Section 16 Planning Application for Proposed Minor Relaxation of Gross Floor Area and Building Height Restrictions for Permitted Office Use and Other Permitted Uses in “Commercial (7)” Zone bounded by King’s Road and Taikoo Shing Road, Quarry Bay (Application No. A/H21/160)

Departmental comments were received via District Planning Office / Hong Kong, Planning Department in March 2026. In response to the departmental comments and public comments received, the Applicants hereby submit a responses-to-comments table with the following attachments for the Board’s consideration:-

PLAN 1 – EXISTING USES BY FLOOR WITHIN “C(7)” ZONE

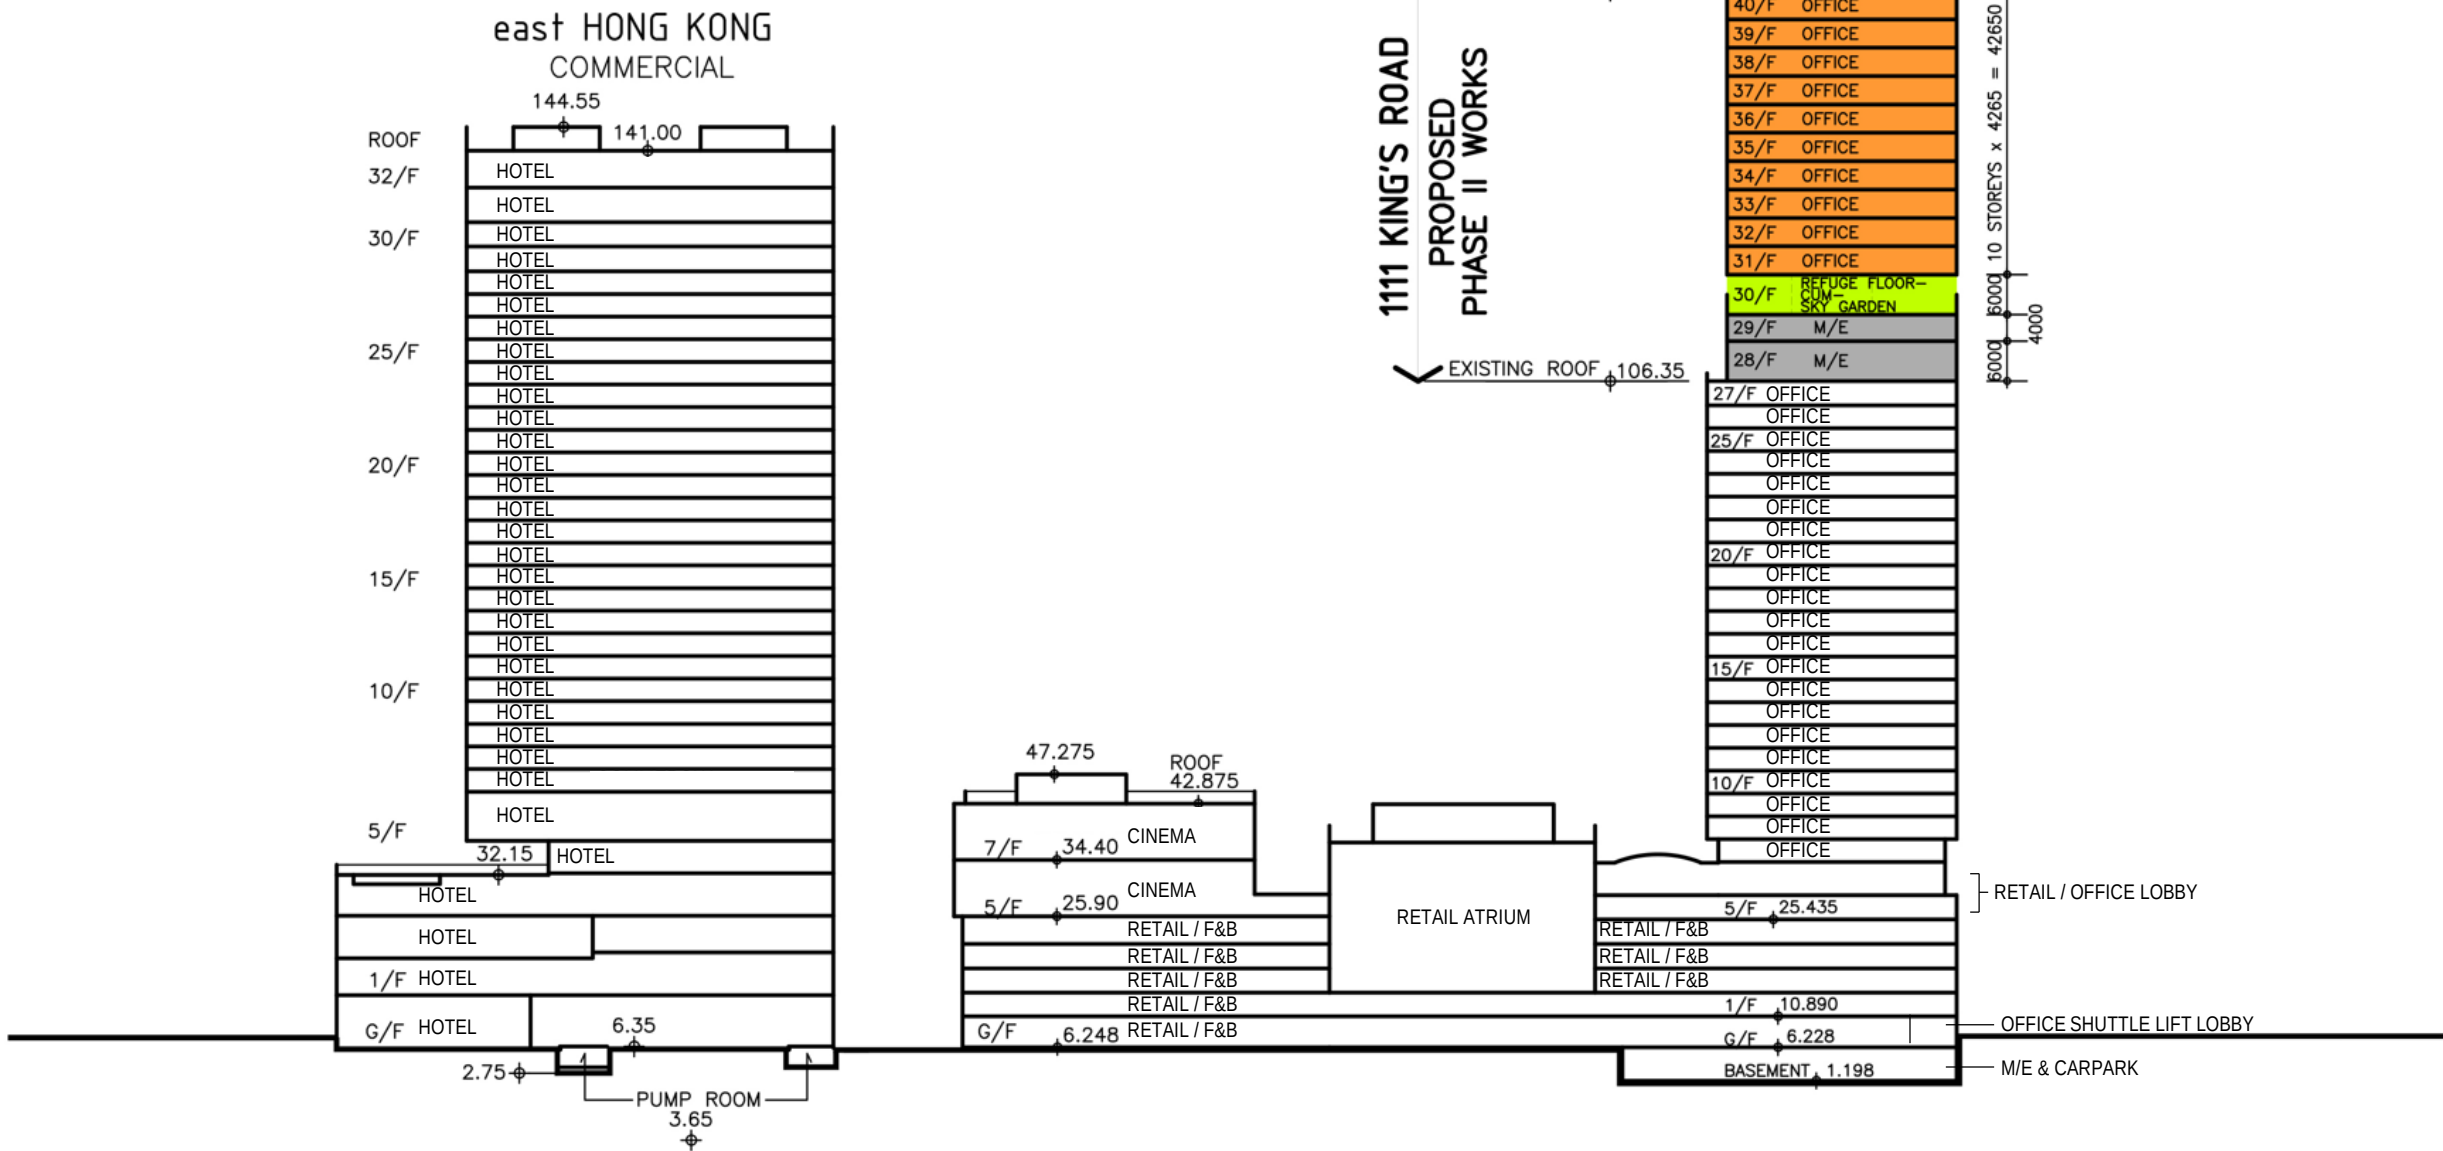
7.6	Figure 3.2 of the Planning Statement (PS) – Please clearly indicate the existing uses by floor for the Development Site as well as the entire “C(7)” zone.	Please refer to Plan 1 under Attachment 3 for the existing uses by floor for the entire “C(7)” zone.
